Securite; Quelin, Francis CCS; Fortier, Carole CCS; Grossas, Jerome
 CCS; Longueville, Christophe CCS; De Cuyper, Eric CCS; Doucet, Alain CCS;
 Giquel, Christian CCS; Sztajnowski, Florent CCS; Chauche, Reynald CCS;
 Cresp, Florent CCS; Jouglet, Emmanuel CCS; Legoff, Jean-Luc CCS;
 VALETTE, Jerome Xavier CCS; Falomir, Stefan Chubb Securite; Monfray, Eric
 CCS
Objet: Flash info Technique : Configuration des LON REP EVAC et EVAC/MES - 670000005 et 006
Importance: Haute

Sur les répéteurs LON REP EVAC et EVAC/MES, le cavalier « S3 » a pour fonction :

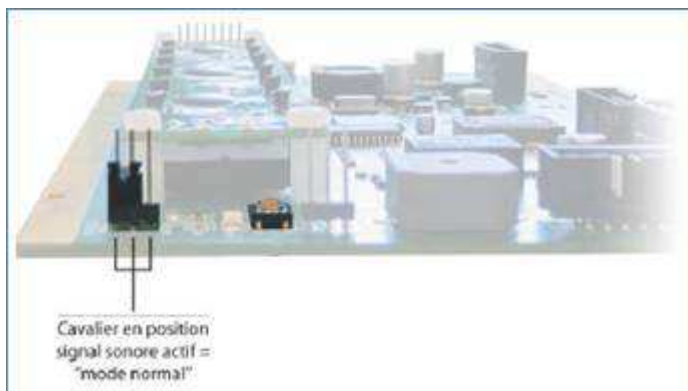
- En position « **Mode NORMAL** » : d'émettre un signal sonore pulsé pendant 1 heure lors d'une perte totale d'alimentation,
- En position « **Mode RESTREINT** » : de ne pas émettre de signal sonore.

A compter d'aujourd'hui, ces répéteurs seront livrés de Cergy avec le cavalier « S3 » en position « **Mode NORMAL** » et non plus en position « Mode RESTREINT » comme c'était le cas précédemment.

La mauvaise position de « S3 » ayant causé des écarts lors d'audits APSAD, il est nécessaire de vérifier ce point lors des visites de maintenance.
